SA	ANDĤAR	Fixture Verification check s	sheet Mag/FVCS/01 REV 00
Sl No.	Process Name	Standard parameters	Date: 2610k 2027 Fixture No: 5004 BX200 DR D) Fixture Description: DIOR Sub Assumbly Customer: 505 THCM Part Name: EX200 Cobin Location: THCM Faboi Co Hion.
1	Condition of Clamps	Should firmly hold the workpiece, Should not create marks on the surface	checked and bund ok
2	Condition of Locating Blocks	Should be free from wear out, Check the flatness using steel rule	Two locating Blocks Not ok
3	Condition of Locating Pins or Hole dia	Check dia and record,Clearance between Hole dia and pin dia should not be more than 0.5mm	checked and found not
4	Locating positions	Should be as per drawing	Os pu past Inspection Report
5	Part resting surface	Should be free from uneven surface, High points (Projections), sticking of foreign particles.	enecked send found ok
6	Bolt and screw Tightness	Free from loose fitment	Checked and found of

16 G 161 V	F/QA/03		G	M QUALITY A		INEERING		NT		1AZ	4DĤMR
			INSP	ECTIO	N RE	PORT					
	T32 059		Customer Name: THOM Engg change level: R a 128.03.18			Sample Qty: •)					
Part Na	ne: DDPR	pudment				Date: 26/04/2023					
Reason	for submission	PILOT	PROTO	PRO

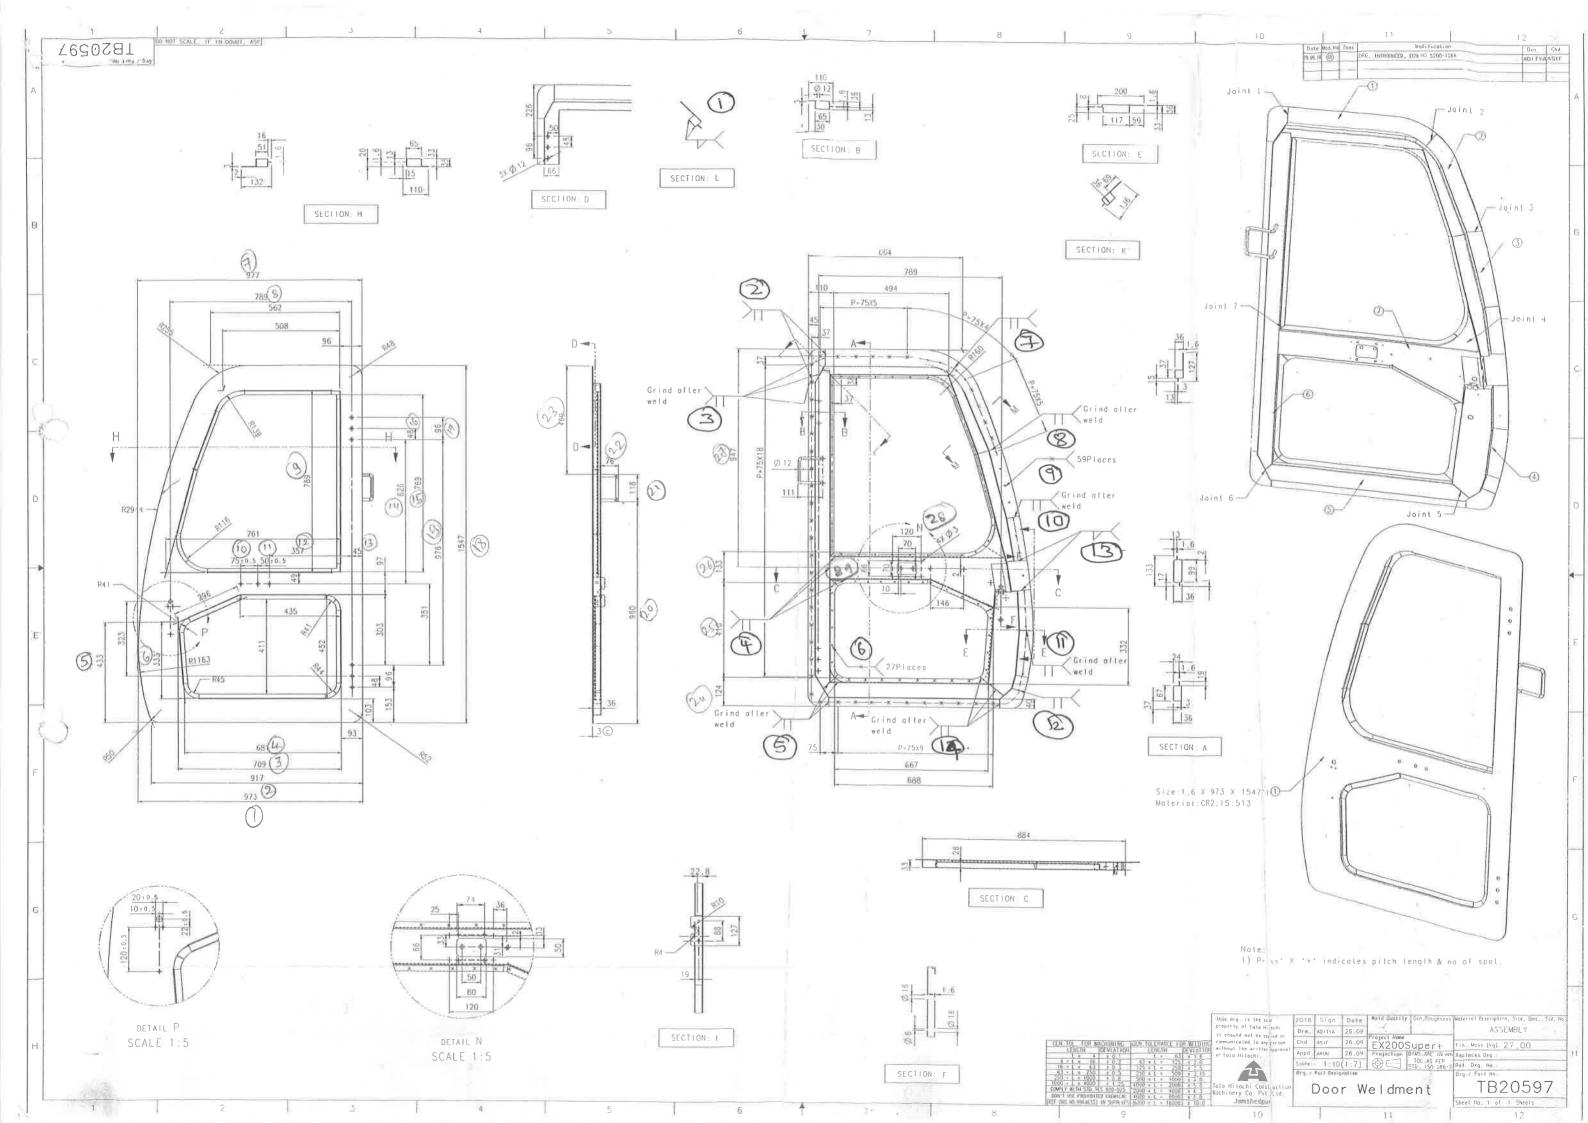
Two locating Block not ok charant between past and Block manually upto 3.73 (unto Block)

2.87 m on manual Top gide Block) Respectively.

(location of locating pins clearant medical clearant medical pins clearant upto 1.7 mon.

Quipposting plate with his Net onestern clear and upto 1.7 mon.

3) lock answering supporting plate & Buch not having lock answering pins grant ally Doing Asjurianunt.
